Product Change Notification

Date Issued :	March 14, 2022	PCN Number :	511648
Reason for Change :	Change Supplier		
Description of Change :	This notification is to inform that a supplier for Molex Lincoln Nebraska is going to change mill sources for raw material impacting the part(s) as per the attached list. No changes will be made to product fit, form or function as part of this change. Change will not result in new supplier, material will still be received by current supplier.		
Assessment of Change :	First Article Inspection		
Planned Implementation Date :	September 14, 2022		
Sample Availability Date:	July 22, 2022		
Internal Molex Qualification Date :	July 22, 2022		
Last date to request Samples by Customer :	August 26, 2022		
Traceability Code Markings / Date :	Product made after planned implementation date can contain the change

- BladeTerminals

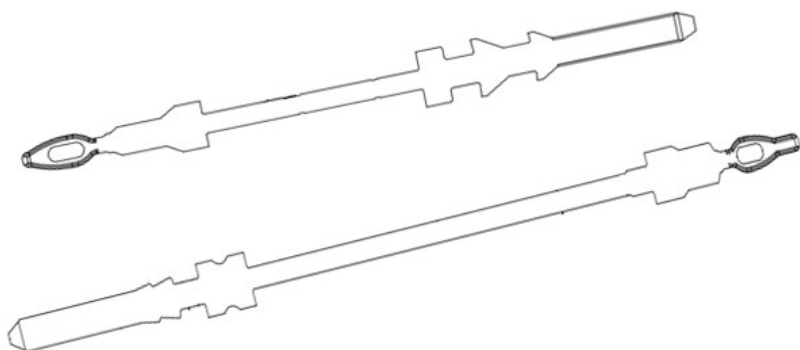
- Molex supplier is changing mill source for raw material
 - New mill source is a Molex approved source
 - Change only for Molex Lincoln Plant 3104
 - Mill source change will not result in new supplier or new supplier location. Molex Lincoln will still receive raw material from same supplier and same supplier location.

- There is NO impact to Fit, Form or Function
